Fire Risk Assessment

Property assessed: 1-62 Sanderson Court Redbrook Avenue Manchester M40 8QJ

Client: Northwards Housing

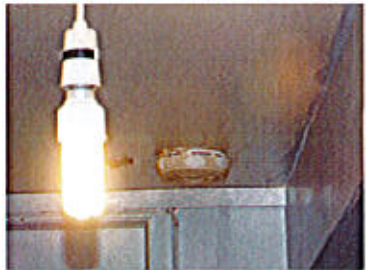
<p>Question - O.3: If required, is directional/exit signage adequate?</p>				No
<p>Comment: Directional and exit signage is not considered adequate. Although there is a single egress route, the primary egress and access route is via the lifts. Most of the exit signs have been removed from the stairs and some from the doors to lobbies and/or stairs.</p>				
<p>Recommendation: Replace the exit signage on the stairs and those flat/lift lobby and stair doors where the signage is missing.</p>				
Priority: B	Known Quantity: 15	Potential Quantity: N/A	Action ID: 112059

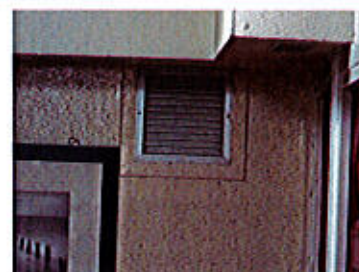
Question - Q.5: If a waste chute is provided within the building are adequate measures in place to limit fire spread/growth? (Consider provision of fusible link dampers and sprinklers etc)				Yes
Comment: A waste chute is provided in the building, which is located in a permanently ventilated area, separated from the escape route by fire resisting construction of at least 30 minutes. Hopper doors are self-closing and have adequate seals. A fusible link damper is fitted to the base of the waste chute.
